UNITED STATES PATENT AND TRADEMARK OFFICE

APPLICATION NO.	FILING DATE	FIRST NAMED INVENTOR	ATTORNEY DOCKET NO.	CONFIRMATION NO.
10/812,426	03/30/2004	Tony A. Cutshall	DEP 5069	3354

Office Action Summary	Application No. 10/812,426	Applicant(s) CUTSHALL ET AL.	
	Examiner TARA R. GEORGE	Art Unit 3733

DETAILED ACTION

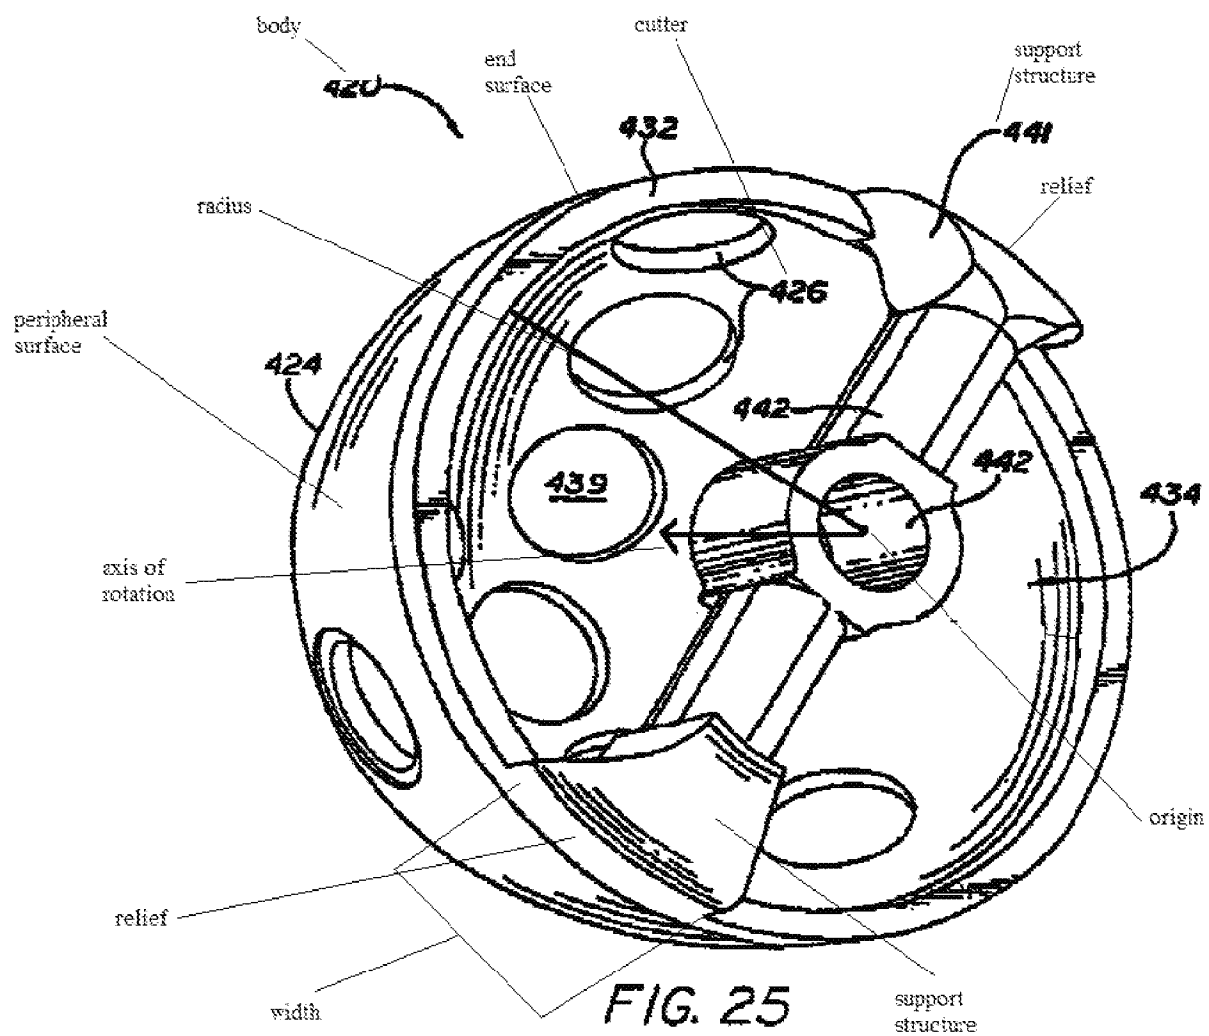
White discloses a reamer comprising a body 420 including a peripheral surface defined by a radius extending from an origin, said body defining an axis of rotation thereof, said body defining an end surface operably connected to peripheral surface and, said body defining a relief surface spaced from the axis of rotation and operably connected to the peripheral surface, wherein a peripheral surface is a hemisphere, with its edges defined by the end surface and the relief surface (see Figure 25 below); a cutter 426 operably associated with said body; a driver connector 442 directly coupled to the end surface (see fig. 26 and note that 441 and 440 and thus, 442, are directly coupled- see col. 12 lines 35-40); and a support structure 441 secured to the relief surface of said body (see Figure 25 below and col. 10 lines 63-67 and col. 11 lines 1-15), the support surface being spaced from the driver connector (via 440- see fig. 26).

The end surface of said body can be generally planar and perpendicular to the axis of rotation of said body; and the cutter and said body can be integral with each other (see Figure 25 below and col. 10 lines 63-67 and col. 11 lines 1-15). The body can also have a general form of a hollow, truncated hemisphere (see Figure 25 below and col. 10 lines 63-67), and the relief surface of said body can also be generally planar and parallel to the axis of rotation (see Figure 25 below). The body can also define a second relief surface spaced from the first mentioned relief surface (see Figures 25 and 29) wherein the second relief surface can define a width dimension therebetween, the width dimension being substantially smaller than twice the radius of said body (see Figure 25 below). The reamer can also further comprise second and third support structures (see fig. 29 and note elements 440 a, b and c) secured to the second relief surface and secured to both first and second support structures for interconnecting said support structures, respectively. Both first and second support structures are spaced inwardly from the driver connector (via 440, see fig. 26; also note fig. 29 and that the driver connector is a bayonet connection). The reamer can also further comprise a driver (see col. 11 lines 7-15). The support structure can also be integral with said body (see col. 11 lines 13-15), and can also comprise one of a rib, a gusset, a bar, a tube, and a plate (see Figure 25 below and col. 11 lines 13-15). The support structure extends

substantially along the relief surface of said body (see Figure 25 below). White further discloses a method comprising providing a cutting tool as disclosed above, cutting an incision in the patient, using the cutting tool to prepare a cavity for the prosthesis; and implanting the prosthesis (see col. 1 lines 20-32, col. 2 lines 44-51 and col. col. 6 lines 10-20).

FIG. 28

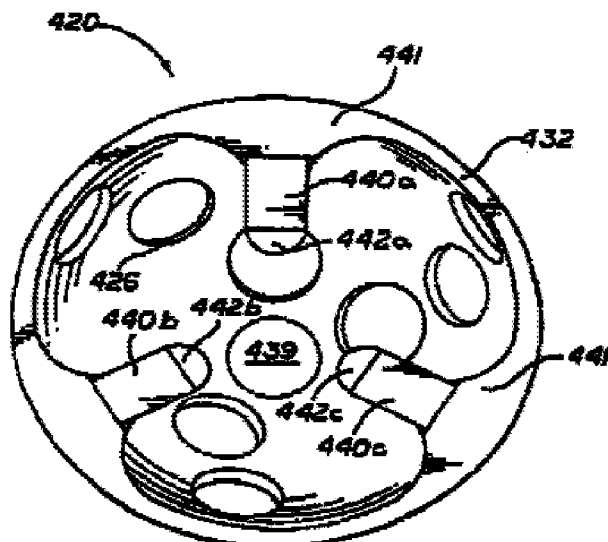
With regards to claims 9, 10, 14, 23, 26 and 33 White discloses angles between the relief surfaces as shown by figures 25, 28 and 29 but does not disclose wherein said angle can be less than 90 degrees, and the distance between the first and second relief surfaces is less than $\frac{2}{3}$ of the radius of the body.

It would have been obvious to one having ordinary skill in the art at the time the invention was made to construct the reamer of White with the first and second relief surfaces defining an included angle therebetween, wherein said angle can be less than 90 degrees, and the distance between the first and second relief surfaces is less than $\frac{2}{3}$ of the radius of the body, since it has been held that discovering an optimum value of a result effective variable involves only routine skill in the art. In re Boesch, 617 F.2d 272, 205 USPQ 215 (CCPA 1980).
